June 26, 2024

This letter is regarding the Oak Basin Dairy, LLC application, Farm ID 6083; Notice of Deficiency dated June 11, 2024.

PROJECT TITLE:  
**Biogas to Energy Expansion  
Newberry / Oak Basin Dairy  
4618 North 200 West  
Rensselaer, IN 47978**

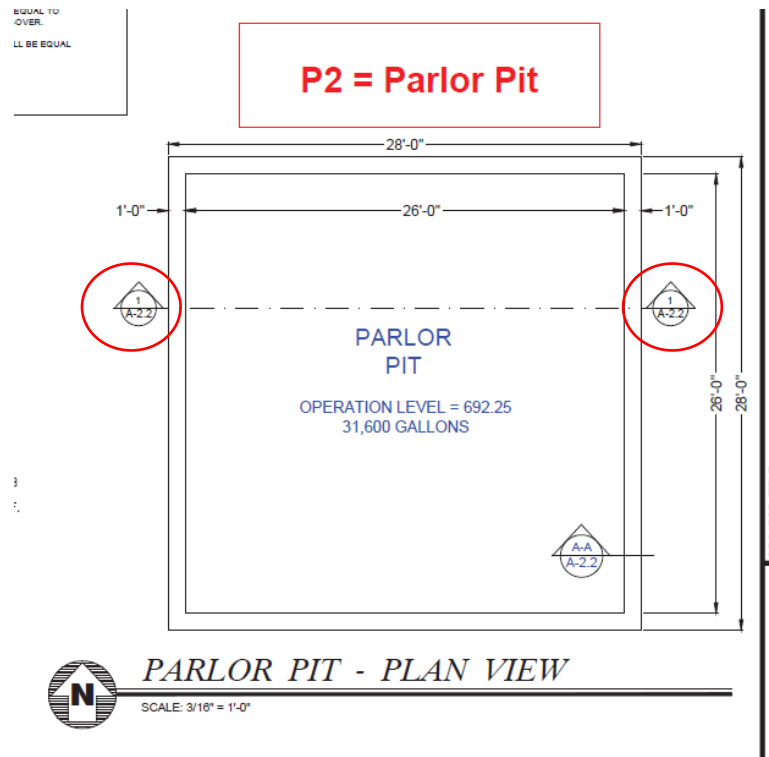
**IDEM Comment 2:** The Facility Detail Sheet notes P1 as storing solid manure, but it seems that it should be marked as liquid. Please update this information.

**Answer:** Please see the attached updated Facility Detail Sheet.

SHEET #  
**A-2.1**

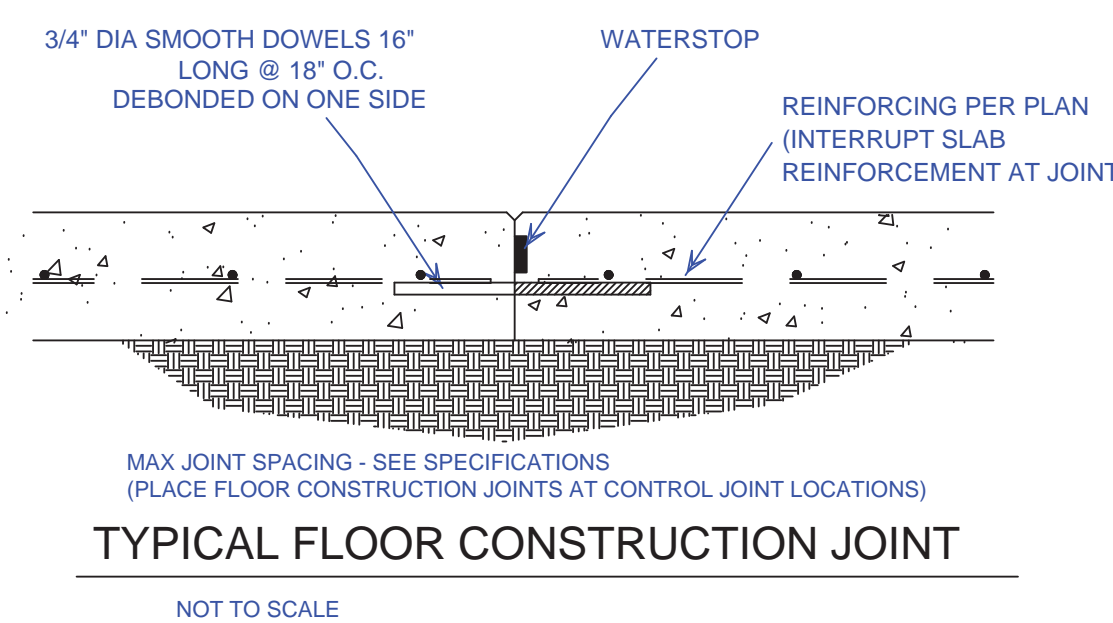
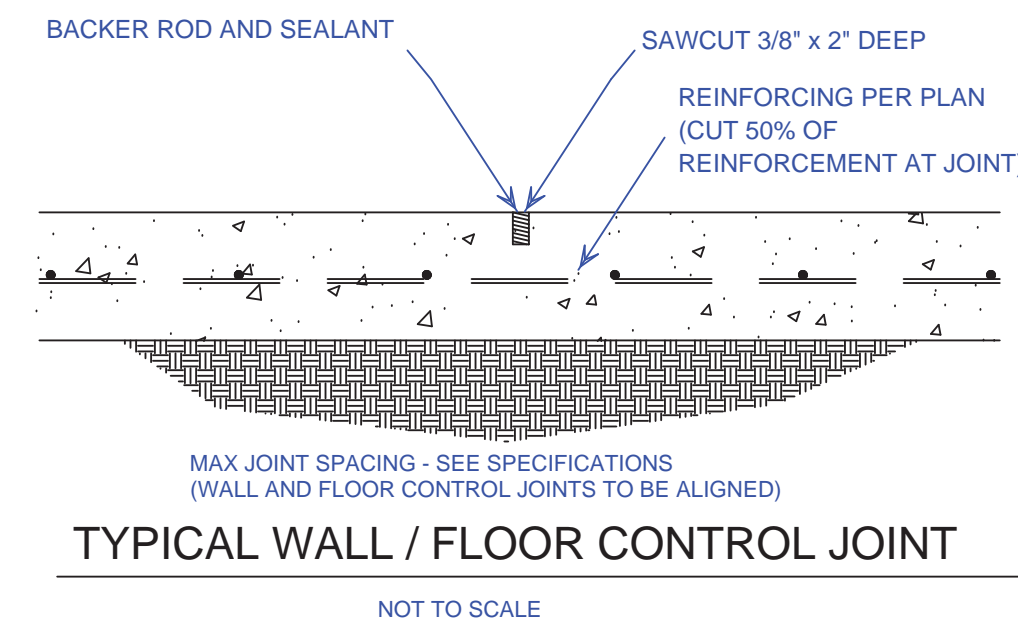
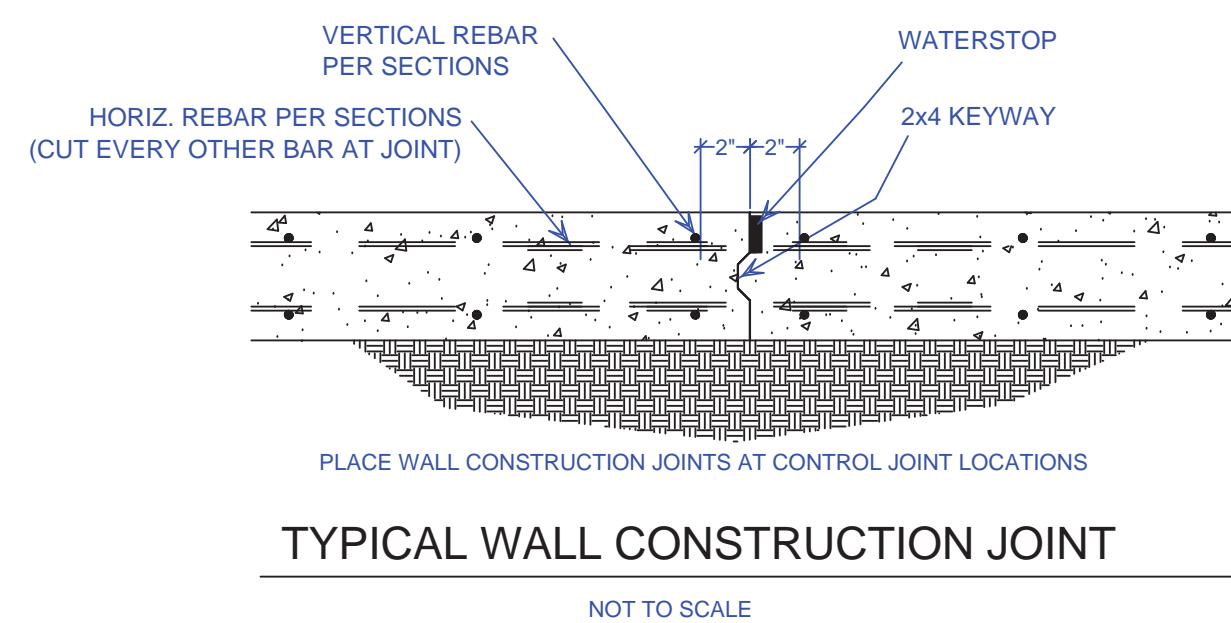
**IDEM Comment 3:** Fibermesh is mentioned throughout the application, but it is unclear if it will be used in construction. Please clarify whether fibermesh will be used. Please note that use of fibermesh (Tuf-Strand or equivalent) will require an ACA. See "Notes on ACA Requirements" below for further details.

**Answer:** Fibermesh was not and will not be used. Please see the attached updated drawings.

PARLOR PIT - PLAN VIEW  
SCALE: 3/16" = 1'-0"

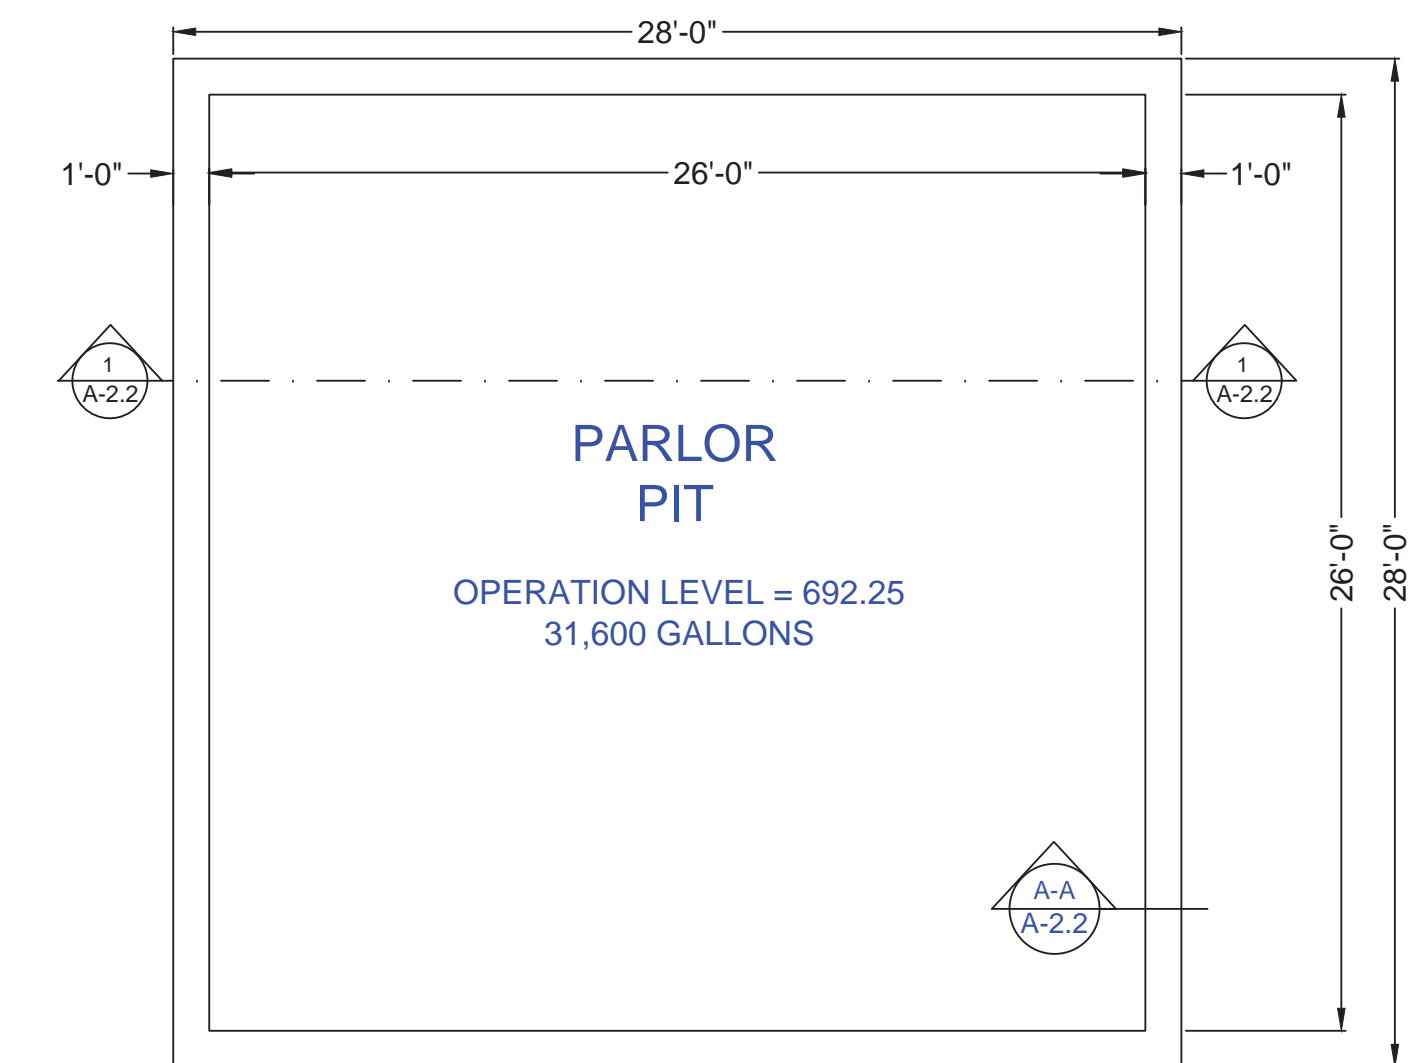
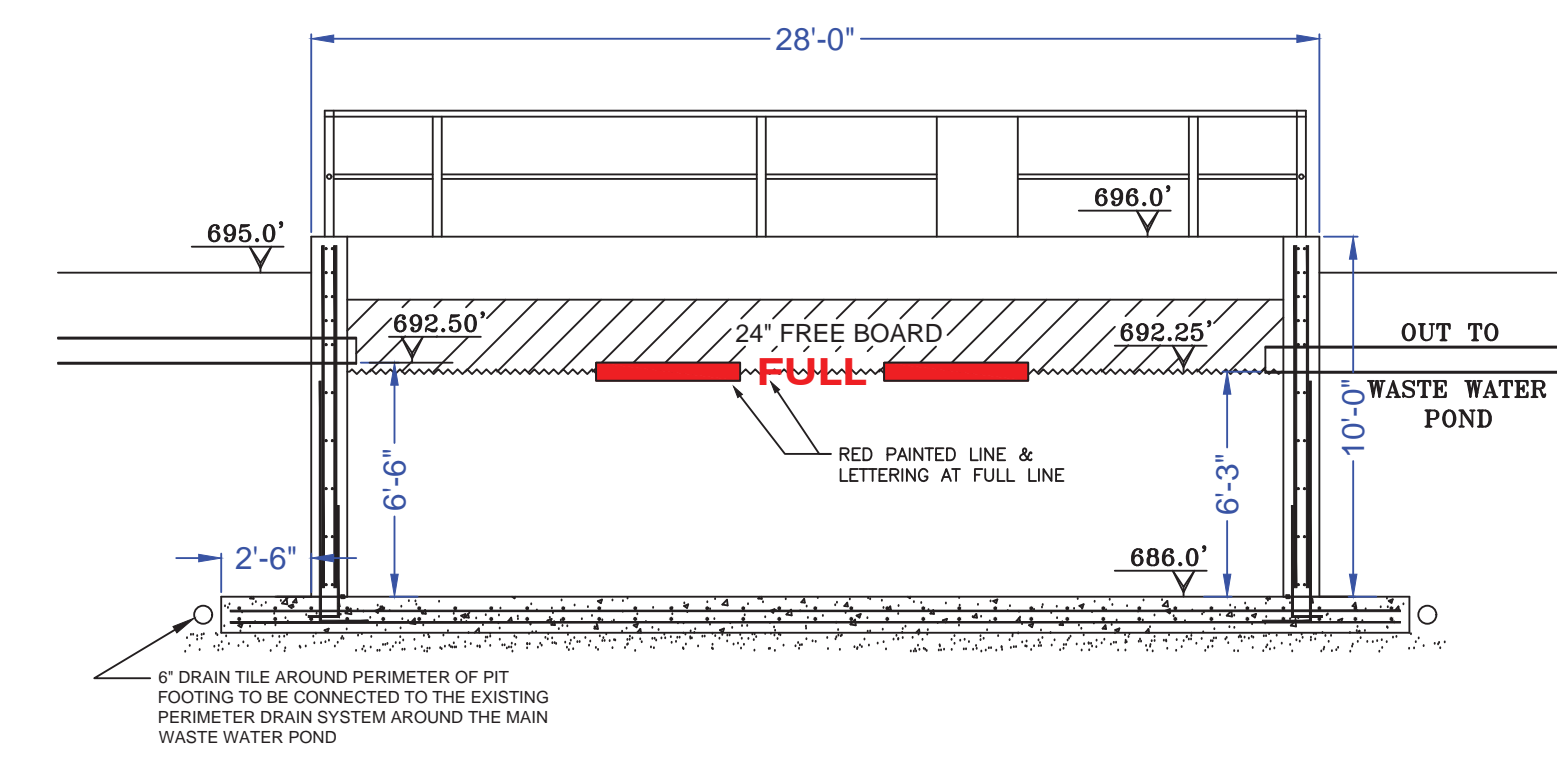
**IDEM Comment 4:** The "Parlor Pit – Plan View" on sheet A-2.2 references detail 1 on sheet A-2.1, but this detail is labeled as being associated with the RDB Digester application only and not this CFO application. Please confirm if this is the correct detail.

**Answer:** The originally submitted sheet A-2.2 "Parlor Pit-Plan View" references detail 1 on sheet A2.2. Review the screen shot of the area below and the attached sheets to confirm. Please contact me if I have misunderstood the sheet/view being discussed.
